NEWINGTON M - 2021

August 31, 2023 (Revised)

Re: Proposed Single Family Dwelling, 115 Frank Fisher Crescent, Lot # 138 White Tail Ridge, Arnprior, Kollaard Associates File # 230020

With regard to structural issues only, Kollaard Associates has reviewed the following drawings:

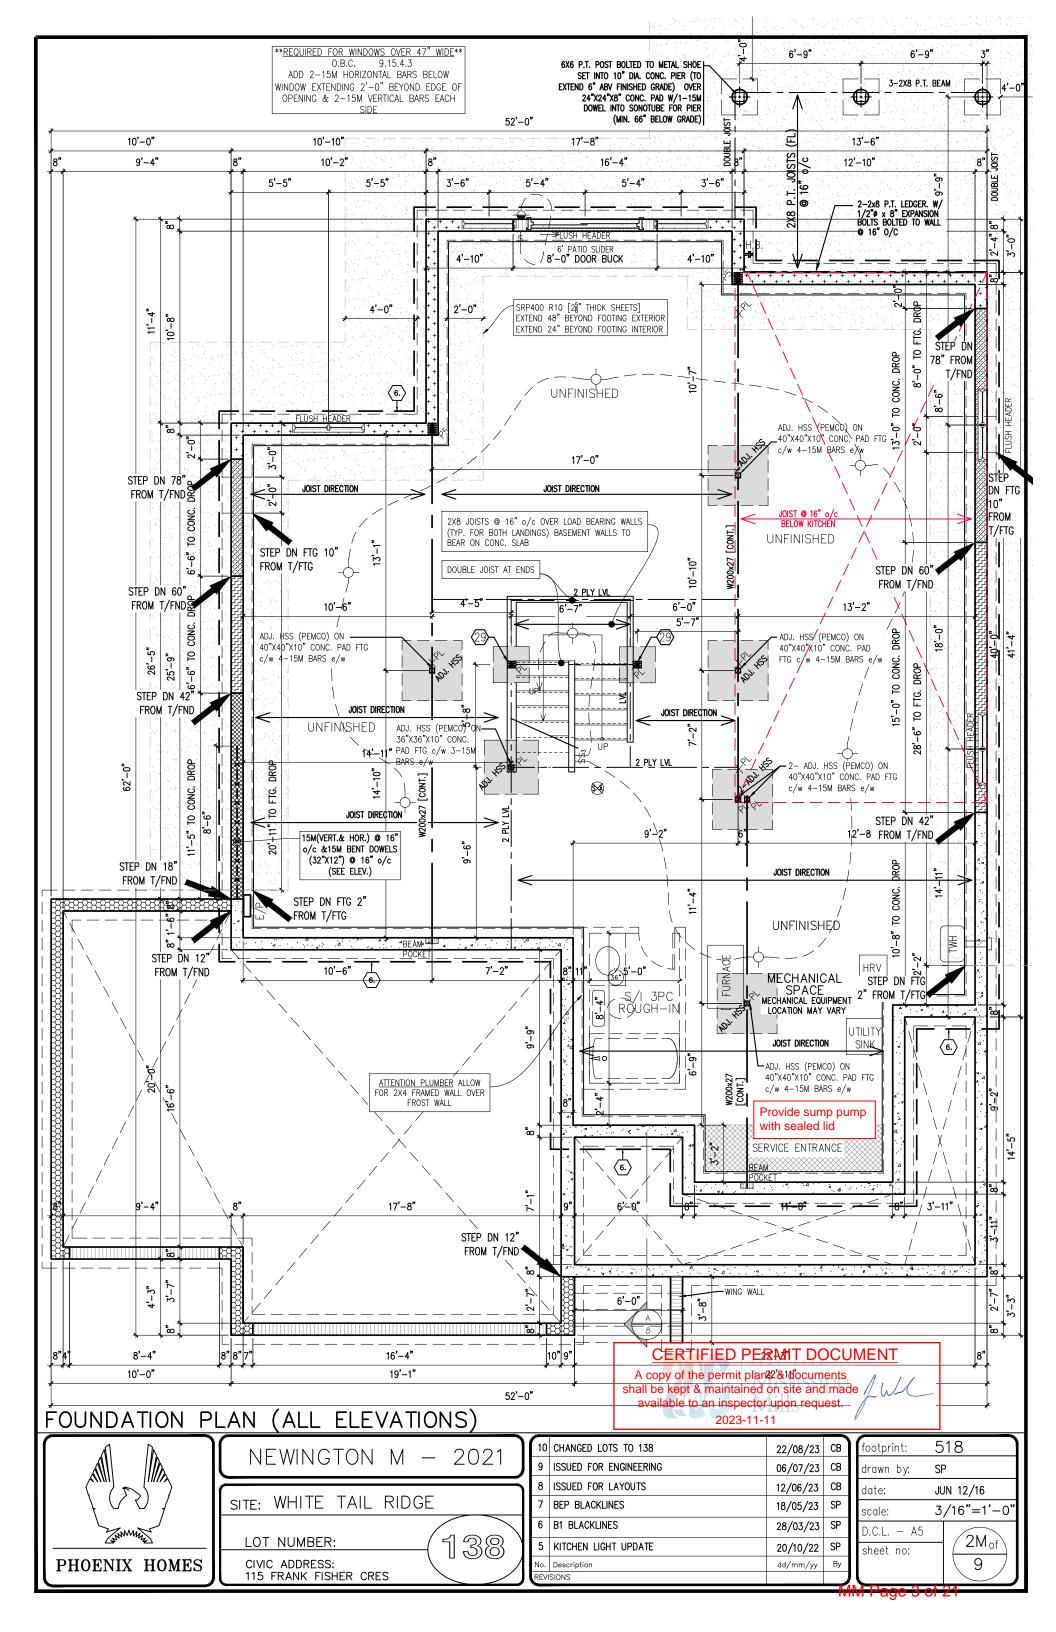
Basement Plan – Pages # 2M:

- 12. It is the opinion of Kollaard Associates that the proposed steel beams and posts shown on Phoenix Homes Sheet # 2M are adequate.
- 13. It is the opinion of Kollaard Associates that the proposed deck beams, posts, joists, sonotubes and ledger connection shown on Phoenix Homes Sheet # 2M and are adequate.

- 14. The front porch slab reinforcement described on Phoenix Homes Sheet # 1M is adequate.
- 15. As noted on Phoenix Homes Sheet # 2M, the framed walls supporting the intermediate landing may be supported by the basement slab.

- 18. The proposed strip footings, interior pad footings and exterior pad footings shown on Phoenix Homes Page # 2M and noted on Phoenix Homes Sheet # 1M are adequate.

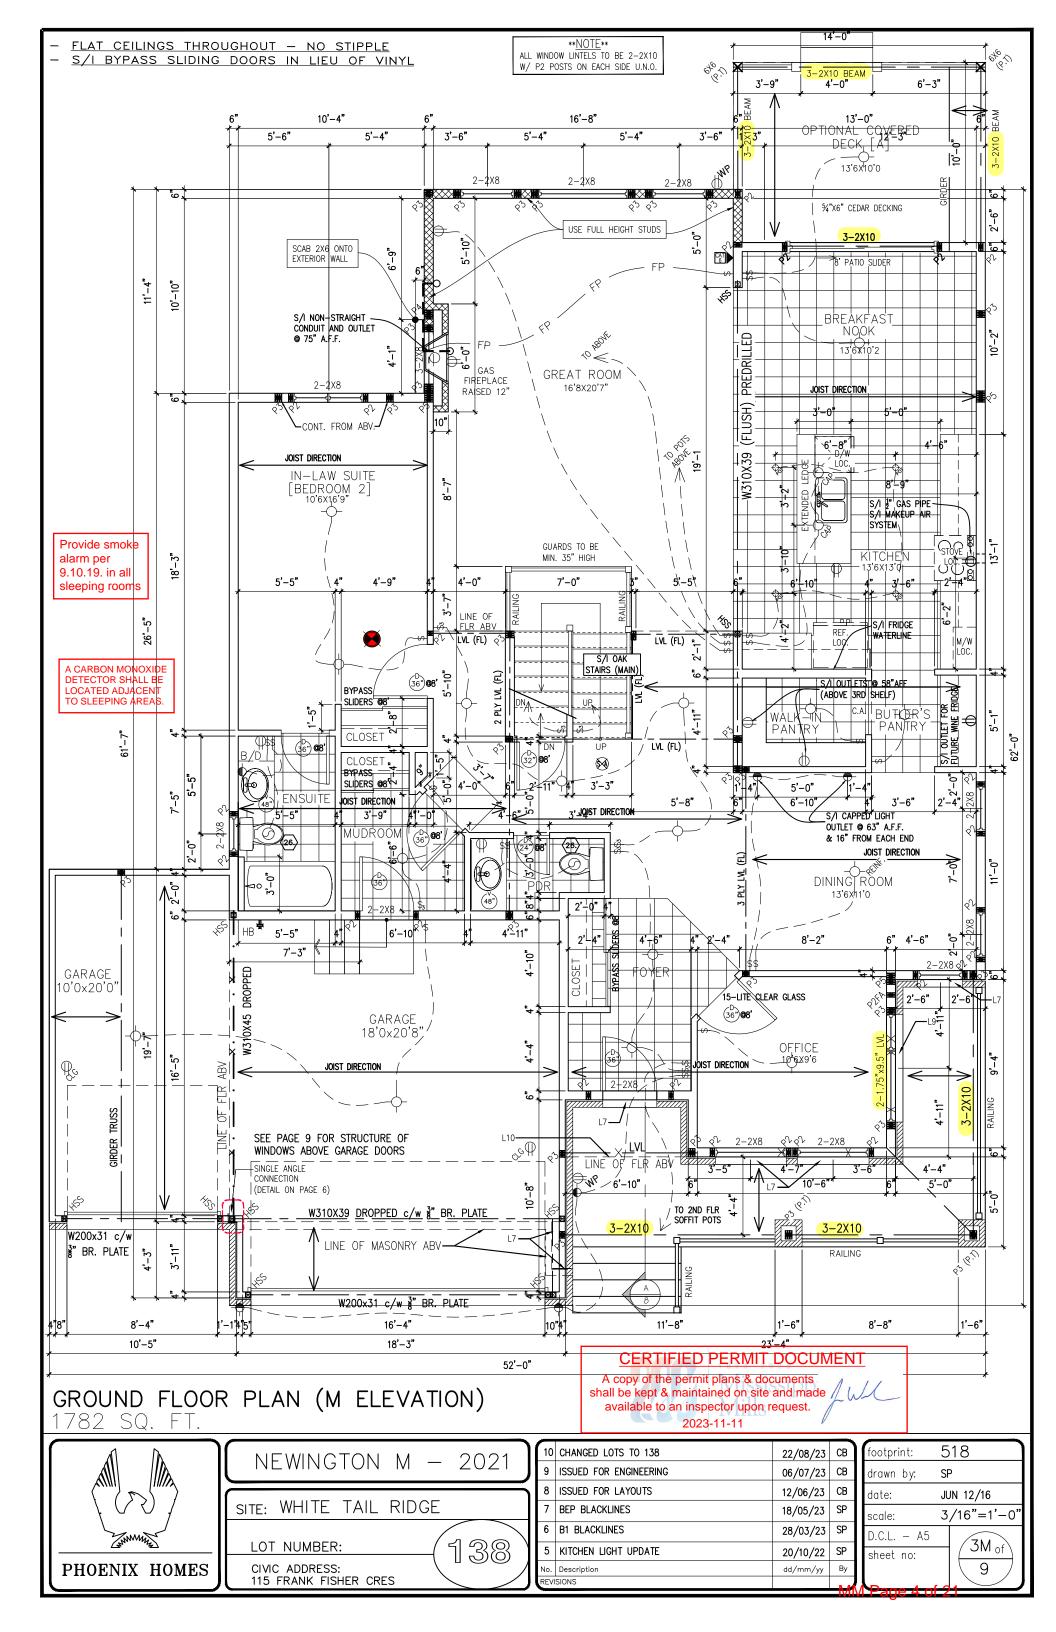
Ground Floor Plan - Pages # 3M:

5. It is the opinion of Kollaard Associates that the proposed lintels, beams and supporting posts shown on Phoenix Homes Pages # 3M are adequate

- 6. Ramset a 2x6 to the top flange of all steel beams to attach the above framing, floor joists and flush LVL beams.
- 7. The proposed web packing of the steel beam detailed on Phoenix Homes Sheet # 9M is adequate.
- 8. The proposed single angle connection of two steel beams detailed on Phoenix Homes Sheet # 6M is adequate.
- 9. Posts supporting girders may consist of built up 2x6 posts as indicated on Phoenix Homes Pages # 3M and are laterally supported by plywood or OSB sheathing (i.e. posts form part of sheathed exterior walls unless noted).
- 10. Truss design is by others.
- 11. Floor joist design and flush LVL beams within the floor structure are by the manufacturer.

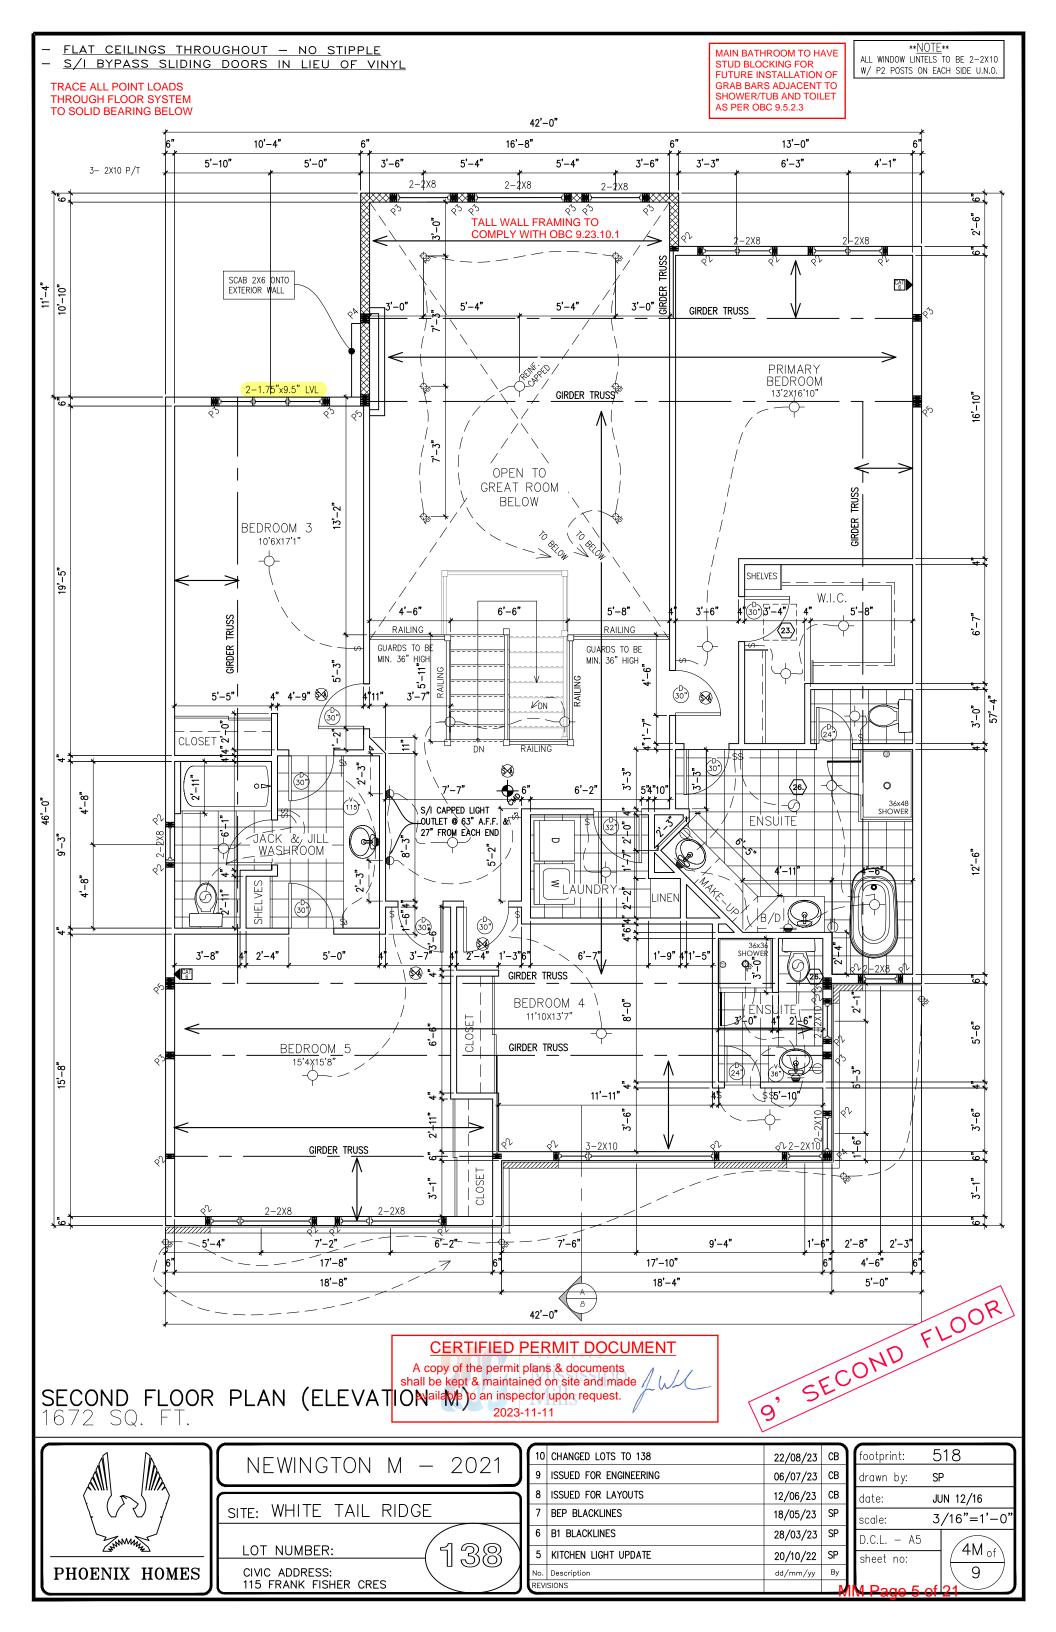
Second Floor Plan - Pages # 4M:

- 1. It is the opinion of Kollaard Associates that the proposed lintels and supporting posts shown on Phoenix Homes Pages # 4M are adequate.
- 2. The proposed tall wall noted on Phoenix Homes Pages # 1 is adequate.
- Posts supporting girders may consist of built up 2x6 posts as indicated on Phoenix Homes Pages #
 4M and are laterally supported by plywood or OSB sheathing (i.e. posts form part of sheathed exterior
 walls unless noted).
- 4. Truss design is by others.
